City of Surrey PLANNING & DEVELOPMENT REPORT Application No.: 7918-0111-00

Planning Report Date: December 4, 2023

- **Rezoning** from RF to CD (based on RM-70)
- Development Permit

Appendix VI. ADP Comments and Response

Project South East Elevation (Building 3)

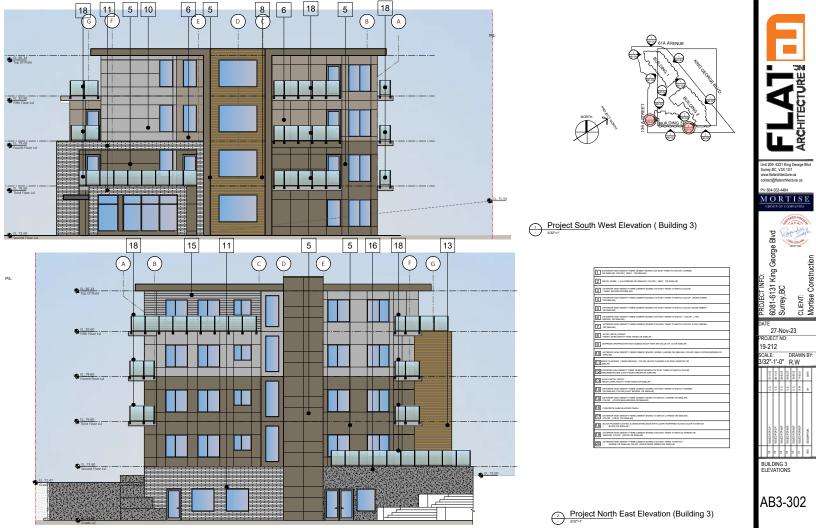
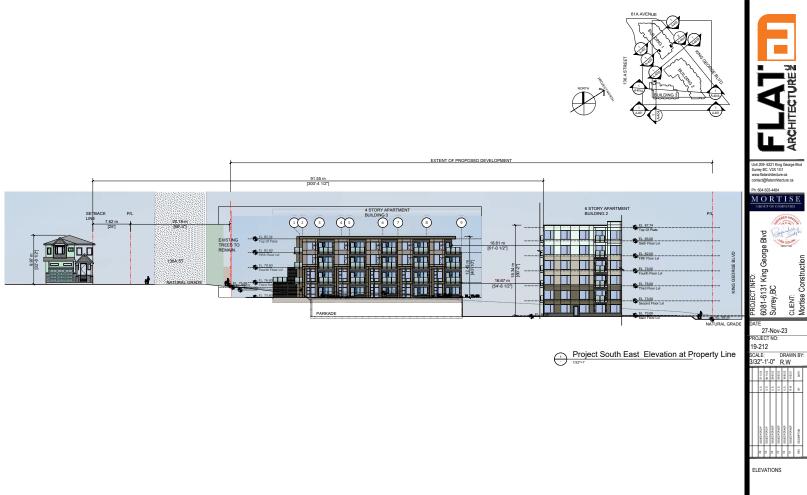
• Consider reviewing the representation of the elevations, since the high sloped roof on Building 3 shows a very large window but the plan shows a solid wall of stair enclosure.

The massing and form have been revised to incorporate the suggestion, we have removed the roof and simplified the elevation to reflect a more neighbourhood friendly design. [U.S.]
